ASSESSMENT REPORT

MACKAS SAND PROJECT

Access Road and Extraction Depth Modification (08_0142 MOD 1)

Figure 3: Proposed LILO intersection

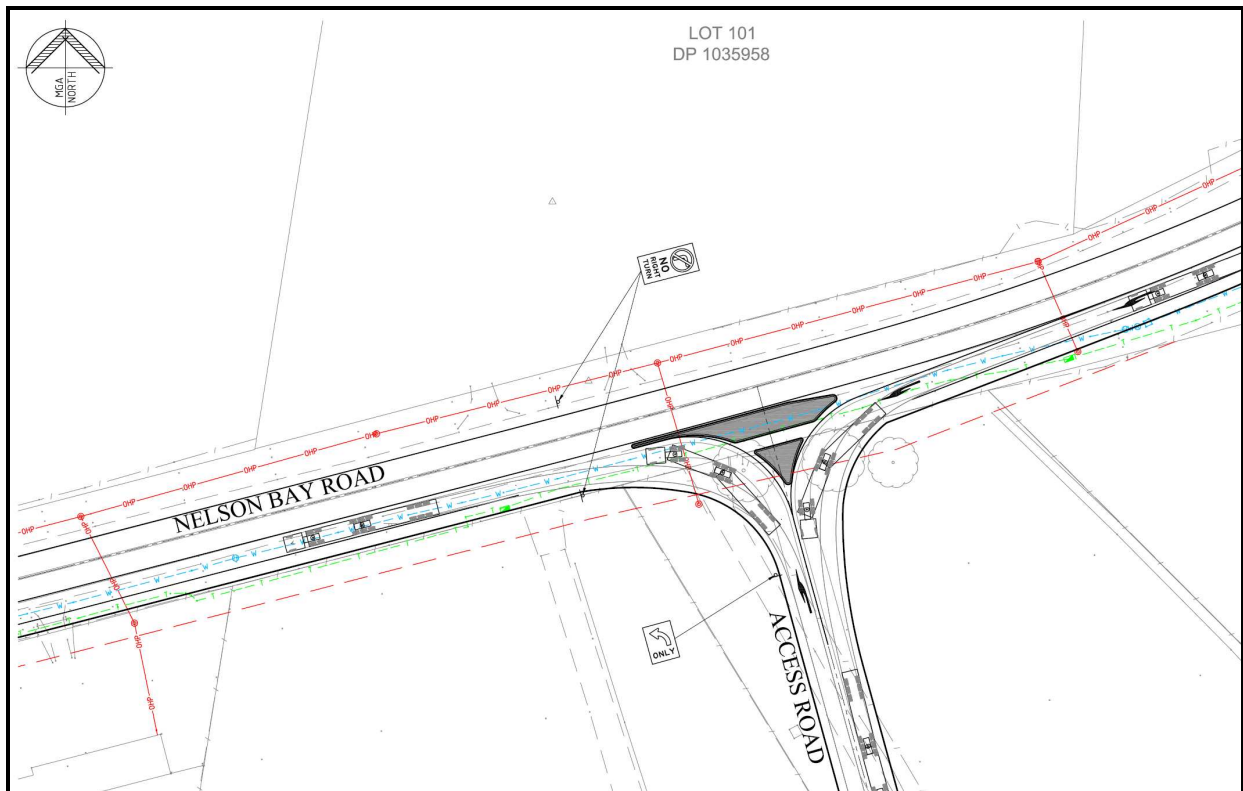
Nelson Bay Road is a classified (ie State) road, with a speed limit of 80 km/hour where the proposed alternate access road intersection would be constructed. RMS and Council are the relevant approval authorities for the two arms of the proposed intersection. RMS gave in-principle support to Mackas Sand's concept intersection design (see Figure 3). This support was contingent on Mackas Sand constructing the intersection to the relevant Austroad standard as a left-in/left-out (LILLO) only access, with acceleration and deceleration lanes for west-bound truck movements into, and out of, the intersection.

This intersection treatment would limit potential road safety impacts by preventing returning quarry trucks from turning right across oncoming traffic on Nelson Bay Road. These trucks would travel 3 km further east away from the proposed intersection, turn at the Richardson Road roundabout and then return to the proposed intersection. The proposed intersection location also complies with relevant sight distance requirements for sand trucks entering Nelson Bay Road (see Figures 4 and 5). The proposed acceleration lane would allow trucks to safely merge at a speed consistent with other vehicles on Nelson Bay Road.

The Department considers that the proposed LILO intersection would allow trucks to safely enter and leave the alternate access road. This proposed treatment would also minimise impacts to traffic flow. The proposed installation of warning signage on the approaches to the intersection would further address potential road safety impacts.

The Department and the RMS consider that the proposed intersection of the alternate access road and Nelson Bay Road can be constructed and operated safely. The proposed LILO design is appropriate and has already been given in-principle approval by RMS. The existing Level of Service of both Nelson Bay Road and the Richardson Road roundabout would be essentially unaffected by the proposed modification. The proposed increase in traffic movements is not significant when considered in the context of the total traffic environment of Nelson Bay Road, whether in peak periods or off-peak periods.

- construct the intersection at its own cost, to the satisfaction of RMS, and in consultation with Council;
- install warning signage ("Trucks Entering") at the eastern approach to the intersection;
- upgrade the access point at the private residence immediately west of the intersection, including warning signage;
- use its best endeavours to gain acceptance from the local bus company that unscheduled stops should not be made in or adjacent to the proposed acceleration or deceleration lanes; and
- restrict the total laden truck movements from Lot 218 to 5 per hour in the morning shoulder period, and to 8 per hour during all other approved periods.

Figure 8: Groundwater environment at Lot 218 and Lot 220

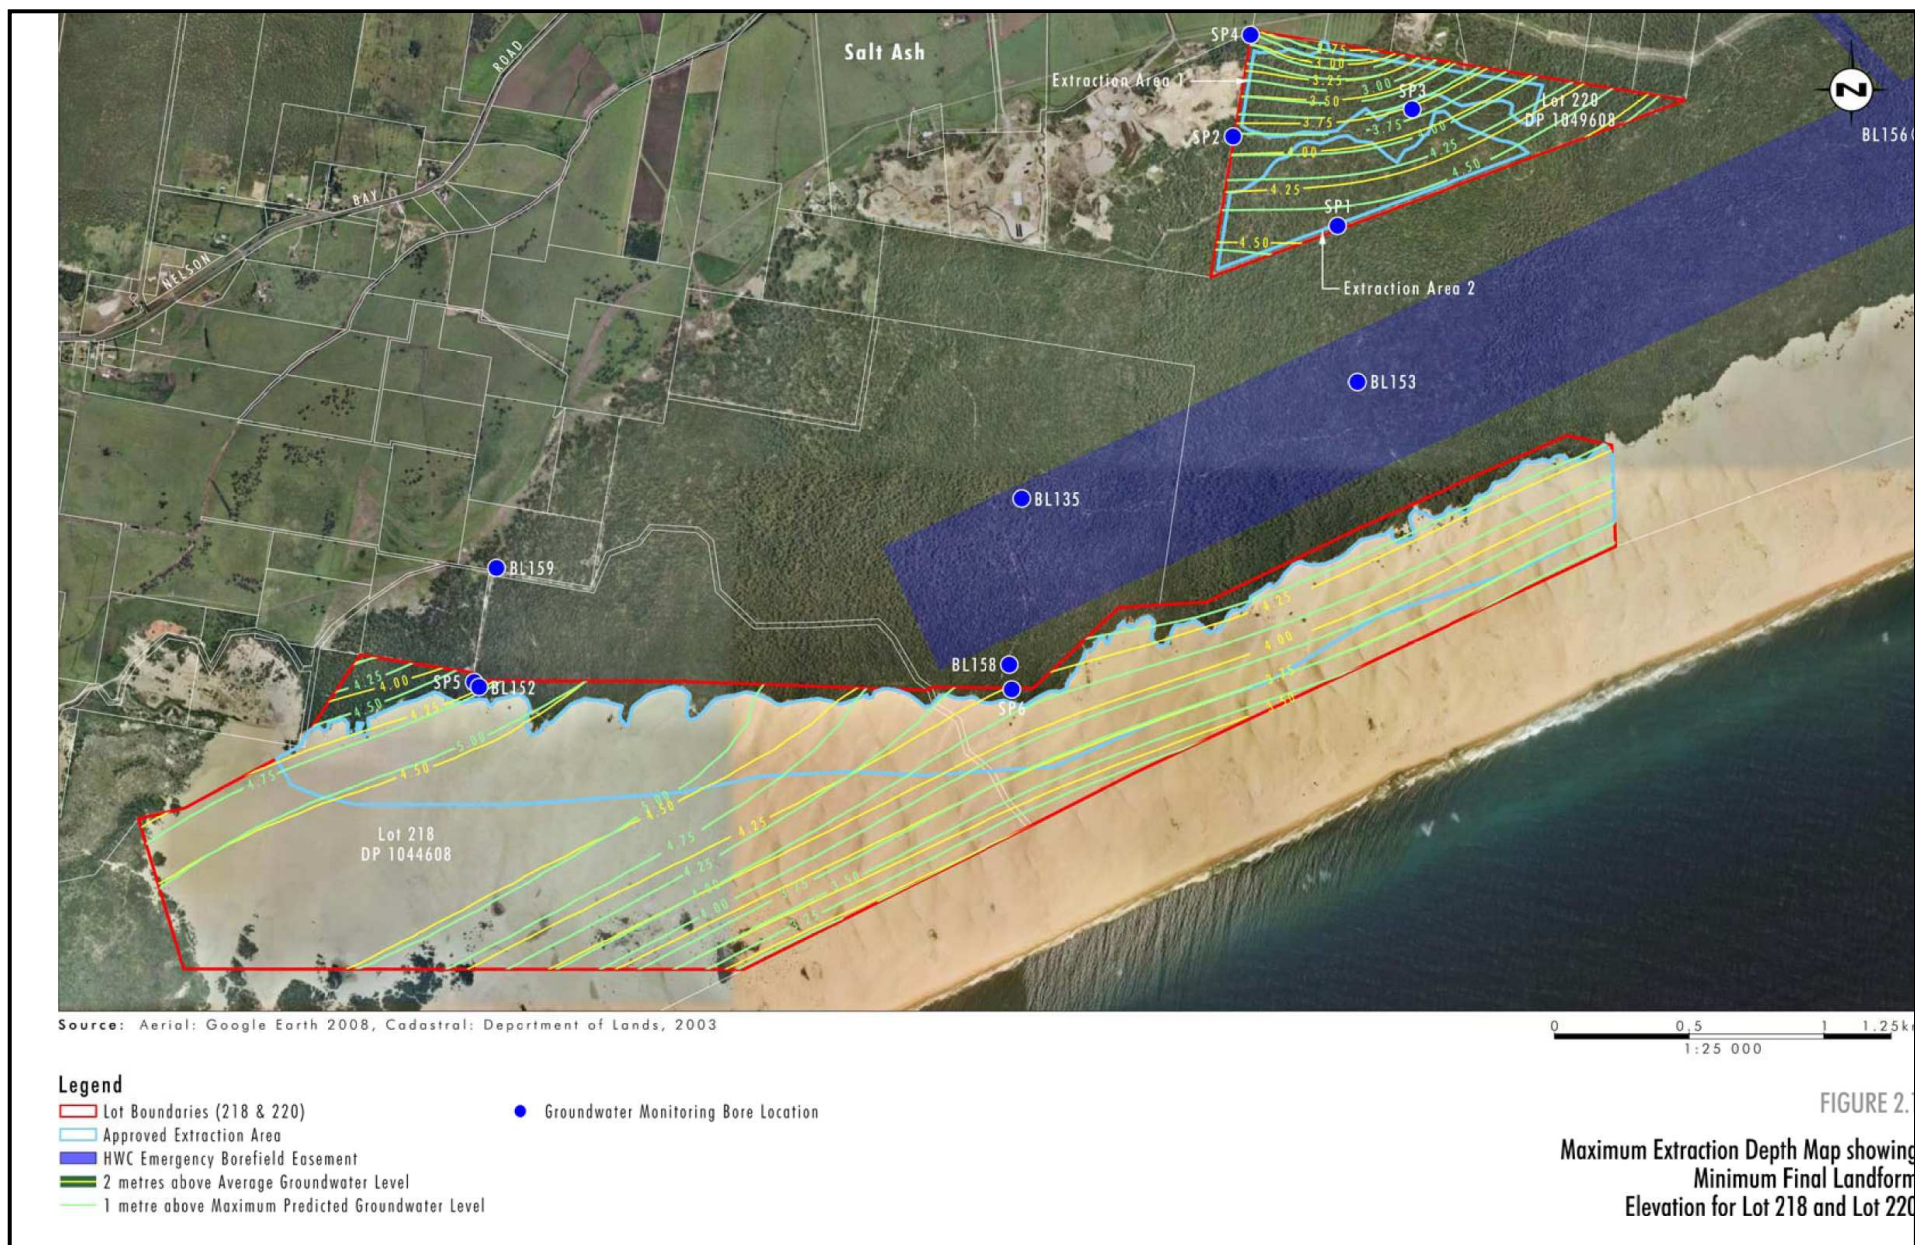
The assessment determined that groundwater drains from the linear topographic high of the Stockton Bight Sand Dunes to both the northwest and southeast. The groundwater contours on Figure 8 indicate this northwesterly drainage from much of the western part of Lot 218, and the drainage downslope towards the Pacific Ocean from the remainder of the site. Groundwater from the Lot 220 extraction area drains northwesterly towards Tilligery Creek.

The Department considers that if above risk management framework is applied, the requirement for the extraction depth to also remain at least 2 m above the average groundwater level can be removed from the approval. This is substantiated by groundwater monitoring, which indicates that there is little difference in the maximum and average groundwater levels in the majority of the approved Lot 218 extraction area (see Figure 8).

To ensure groundwater impacts continue to be closely managed for the modified project, the Department has recommended that Mackas Sand reviews and revises its approved Soil and Water Management Plan. The Department is also satisfied that Mackas Sand would be able to successfully rehabilitate the two sites to the approved ground surface levels on completion of the project, and in accordance with the approved Landscape Management Plan.
